UNITED STATES PATENT AND TRADEMARK OFFICE

APPLICATION NO.	FILING DATE	FIRST NAMED INVENTOR	ATTORNEY DOCKET NO.	CONFIRMATION NO.
10/602,547	06/24/2003	Kyle Bateman	2280.ACTI.NP	1226
27472	7590	05/19/2006	EXAMINER CHAMBERS, TROY	
RANDALL B. BATEMAN BATEMAN IP LAW GROUP 8 EAST BROADWAY, SUITE 550 PO BOX 1319 SALT LAKE CITY, UT 84110			ART UNIT 3641	
DATE MAILED: 05/19/2006

Office Action Summary

DETAILED ACTION

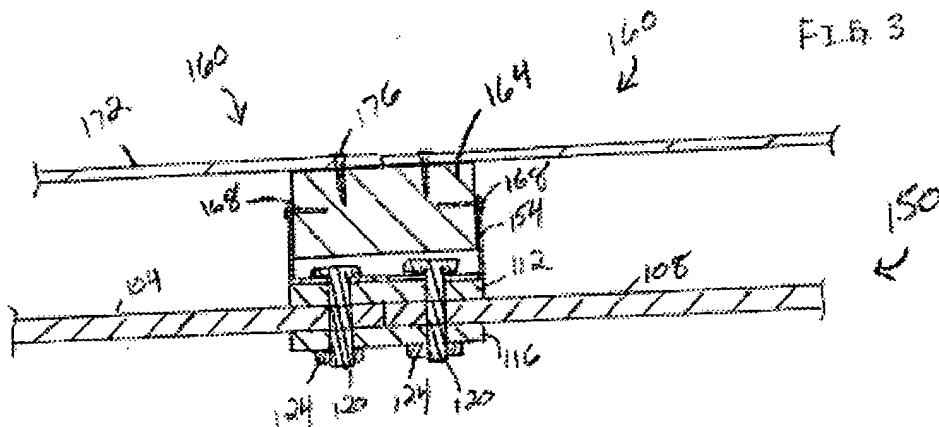
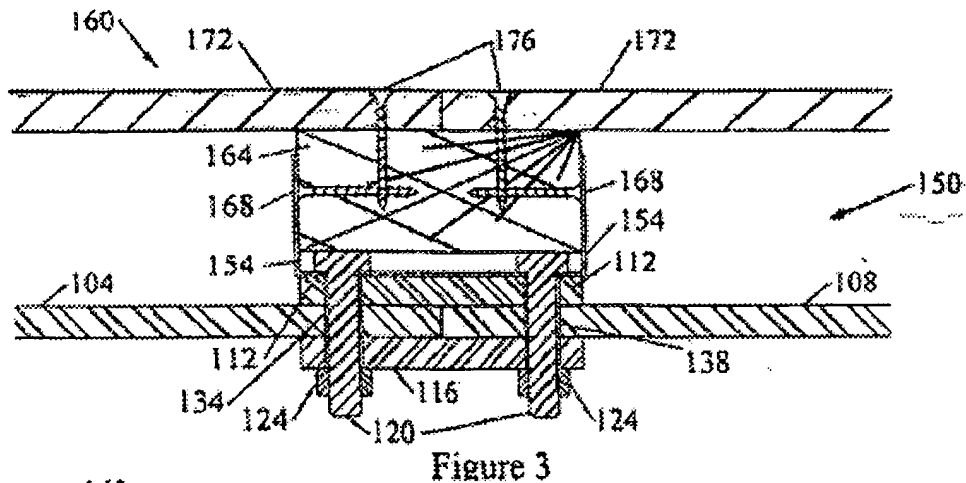
2. The Examiner has noticed an inconsistency between the Figure 3 filed with provisional application 60/395540 and the most recent Figure 3 filed in the instant application. As shown below, in the provisional application, the two-by-four 164 is spaced away from the bolts 120 while in the instant application the two-by-four is up against or touching the bolts 120.

The following Figures are considered admitted prior art disclosures:

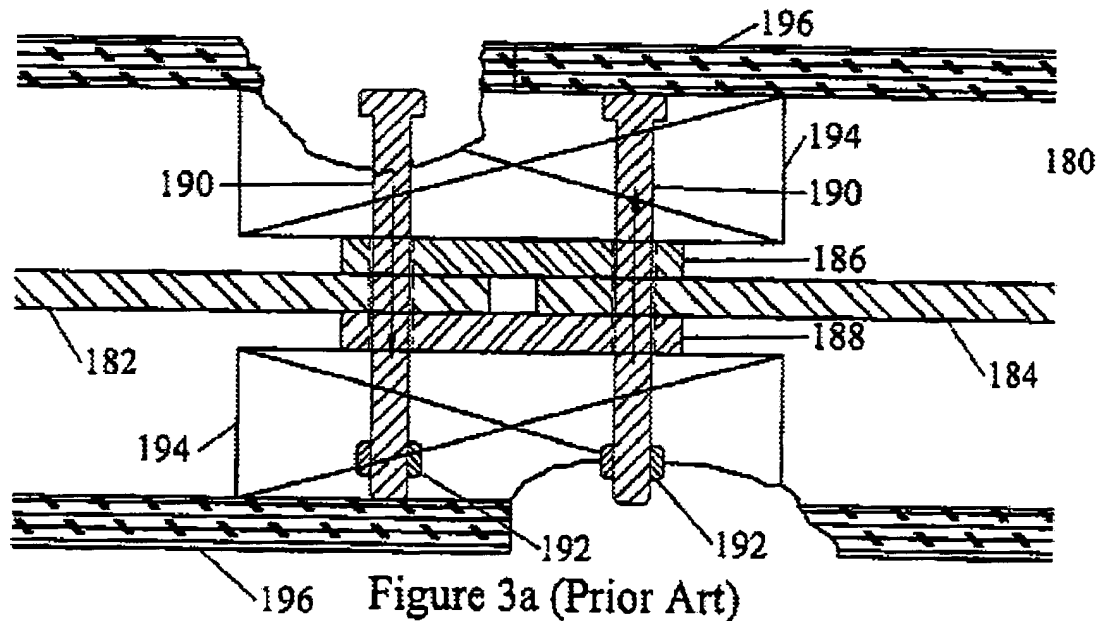
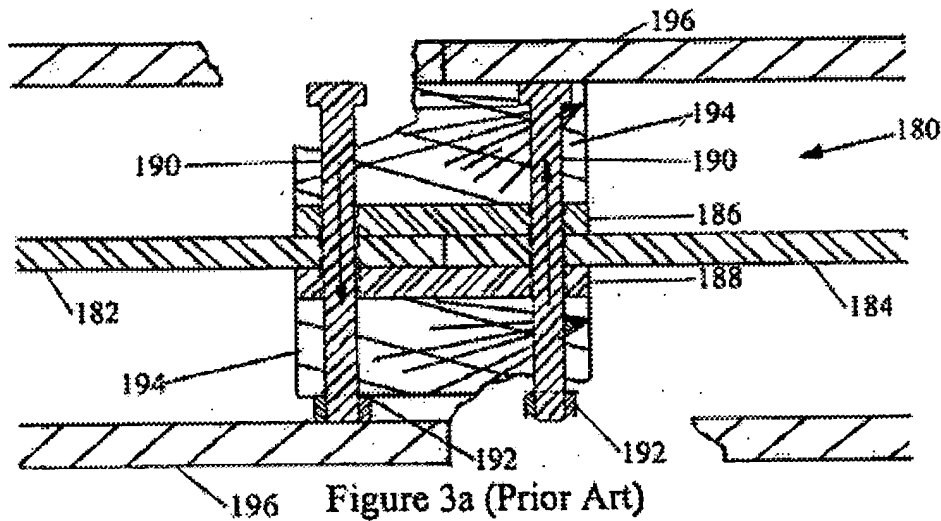
Applicant submitted both figures as prior art and will be considered so for the duration of prosecution. If used in a rejection, the top prior art figure will be hereinafter known as "Fig. 3a New" while the bottom prior art figure will be known as "Fig. 3a Old".

17. Claims 1-3, 21, 36, 37 and 39 are rejected under 35 U.S.C. 102(b) as being anticipated by Prior Art Fig. 3a Old. Figure 3a Old discloses a modular ballistic wall having first and second plates, keyholes (see interpretation of keyhole), facing/backing strip and a plurality of bolts and nuts. Figure 3a Old

also discloses a containment frame comprising a wood post. With respect to claim 21, at least one arm (bolt arm) extends away from the pieces of plate steel. With respect to claim 36, the wood post completely covers an attachment mechanism (nuts and bolts) when viewed in a direction perpendicular to the wall. With respect to claim 39, it does not appear that bolt 190 extends all the way through containment frame 194.
